ARKANSAS NUCLEAR ONE - UNIT NO. 1

AMENDMENT TO FACILITY OPERATING LICENSE

Amendment No. 31  
License No. DPR-51

SAFETY EVALUATION BY THE OFFICE OF NUCLEAR REACTOR REGULATION  
SUPPORTING AMENDMENT NO. 31 TO FACILITY OPERATING LICENSE NO. DPR-51

Figure 3.5.2-1A

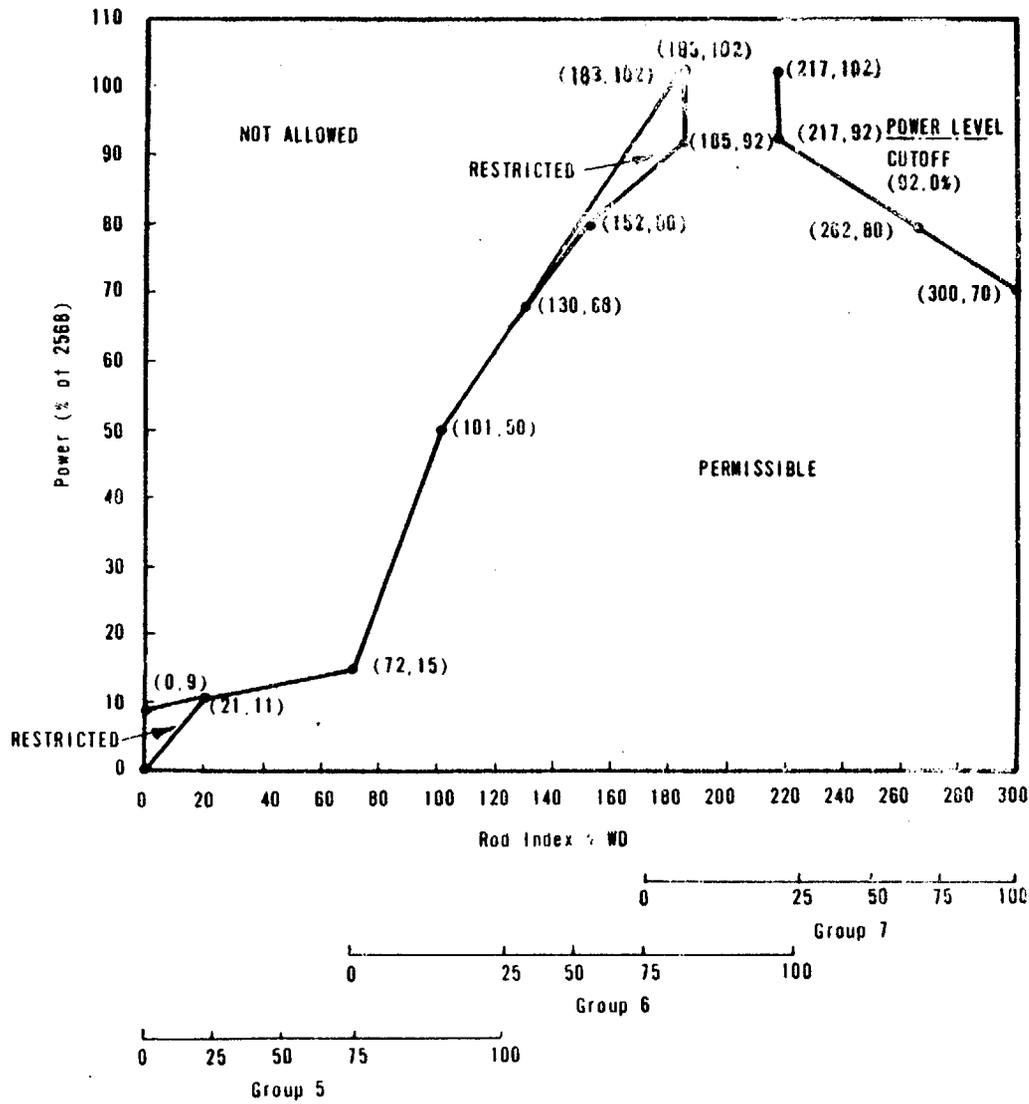
3. Except for physics tests or exercising control rods, a) the control rod withdrawal limits are specified on Figures 3.5.2-1A, 3.5.2-1B and 3.5.2-1C for four pump operation and on Figures 3.5.2-2A, 3.5.2-2B and 3.5.2-2C for three or two pump operation and b) the axial power shaping control rod withdrawal limits are specified on Figures 3.5.2-4A, 3.5.2-4B and 3.5.2-4C. If any of these control rod position limits are exceeded, corrective measures shall be taken immediately to achieve an acceptable control rod position. Acceptable control rod positions shall be attained within four hours.

Figure 3.5.2-3A

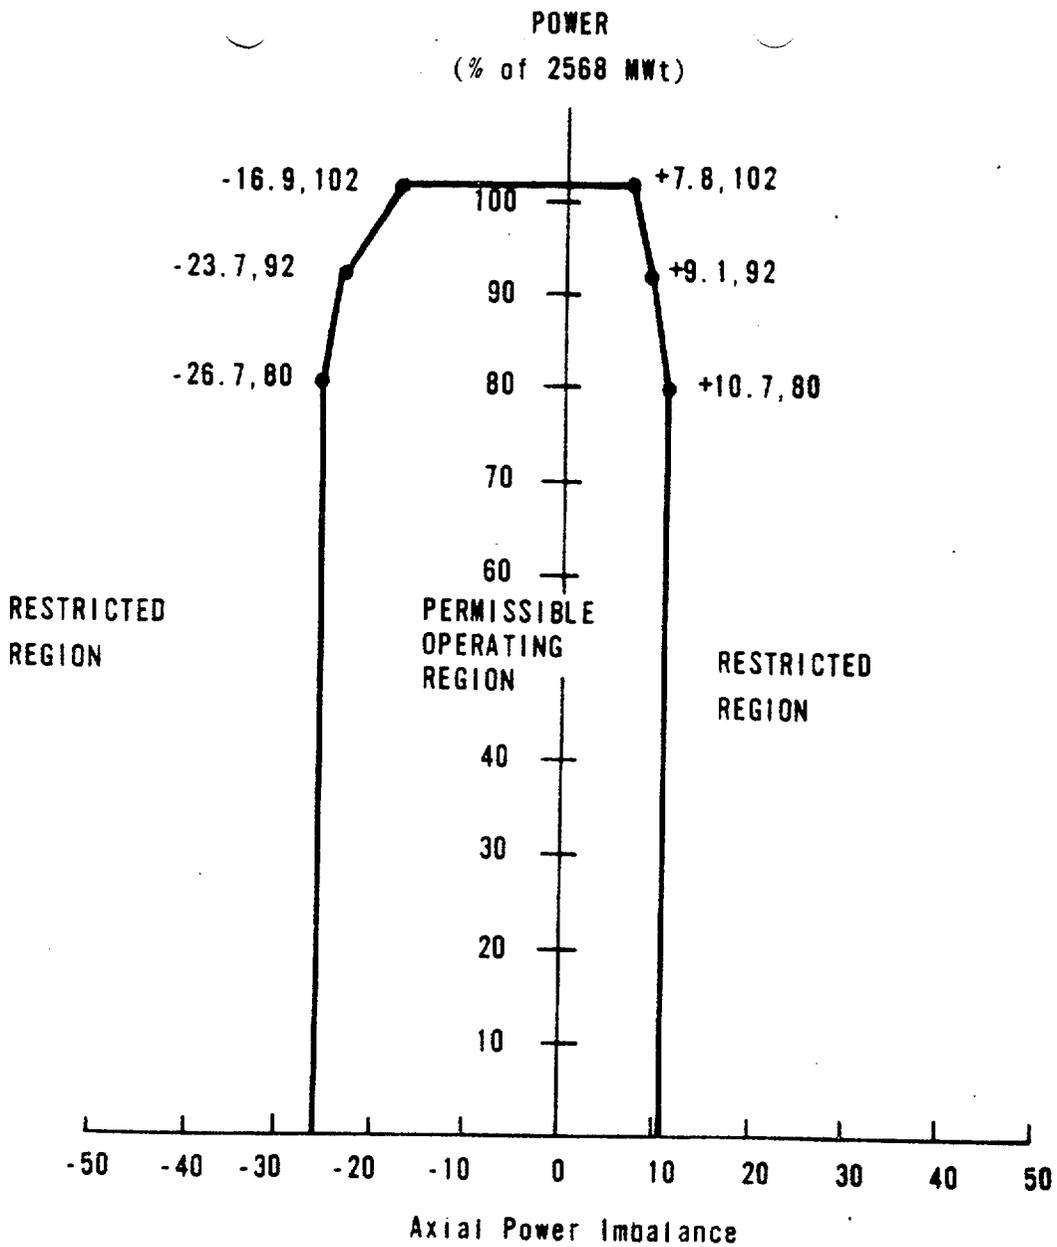
- 3.5.2.6 Reactor Power Imbalance shall be monitored on a frequency not to exceed two hours during power operation above 40 percent rated power. Except for physics tests, imbalance shall be maintained within the envelopes defined by Figures 3.5.2-3A, 3.5.2-3B and 3.5.2-3C. If the imbalance is not within the envelopes defined by Figures 3.5.2-3A, 3.5.2-3B and 3.5.2-3C corrective measures shall be taken to achieve an acceptable imbalance. If an acceptable imbalance is not achieved within four hours, reactor power shall be reduced until imbalance limits are met.

APSR POSITION LIMITS FOR OPERATION FROM  
 0 TO 100 ± 10 EFPD ANO, CYCLE 3  
 Figure 3.5.2-4A

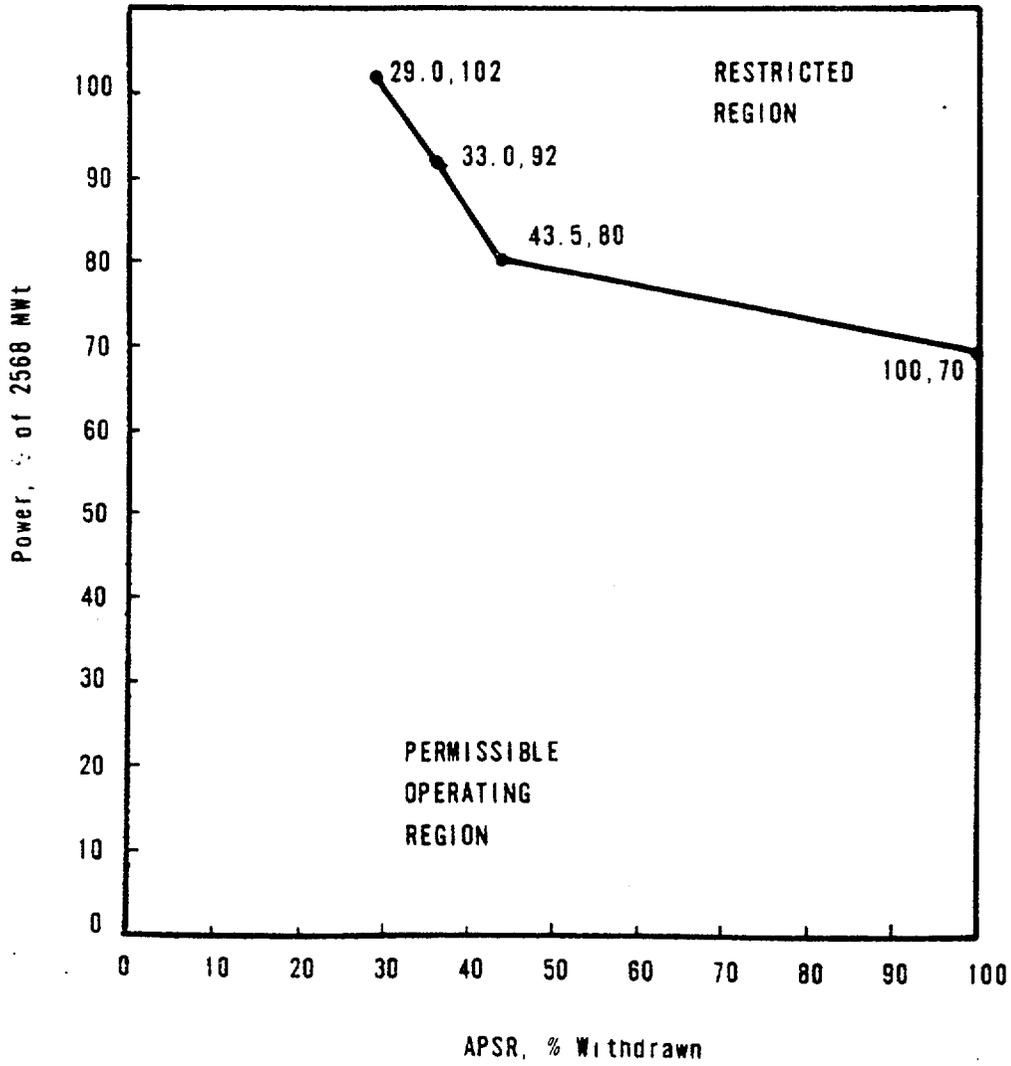
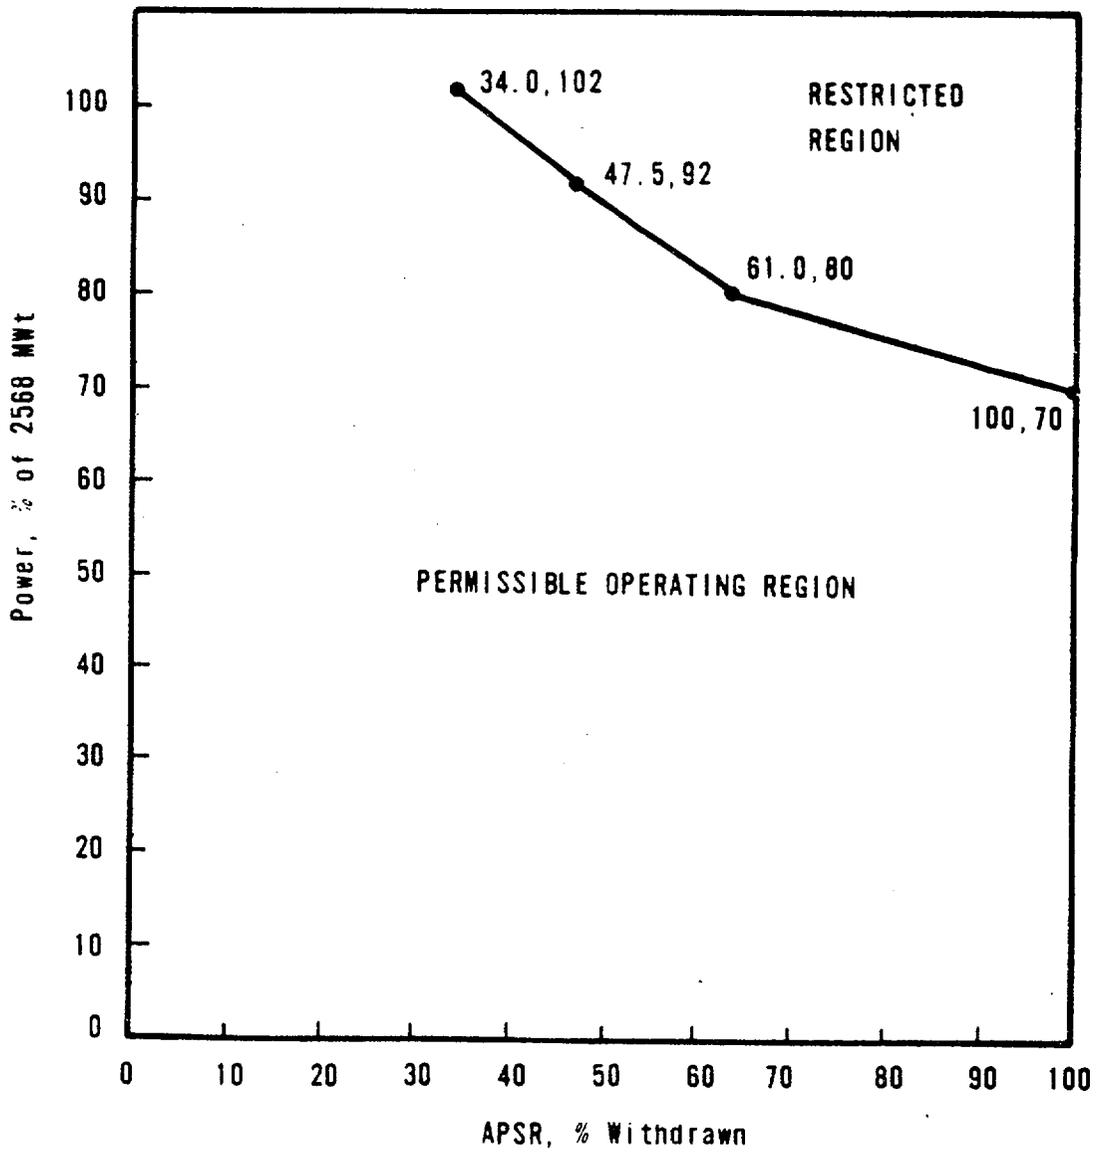
The only significant proposed operational procedure change is the proposed Technical Specification change of the axial power shaping rod (APSR) position limits. The APSR position limits would provide added control of power peaking to insure that peak power limits for Loss of Coolant Accident (LOCA) conditions would not be violated.

We find that, based on the AP&L's nuclear analysis techniques and their commitment to perform acceptable physics startup testing, the ANO-1 nuclear analysis is acceptable. We also find the proposed Technical Specifications of APSR position limits and the usual regulating control rod and imbalance limits, which assure that the loss of coolant accident (LOCA) LHGR limits are not exceeded, are acceptable.
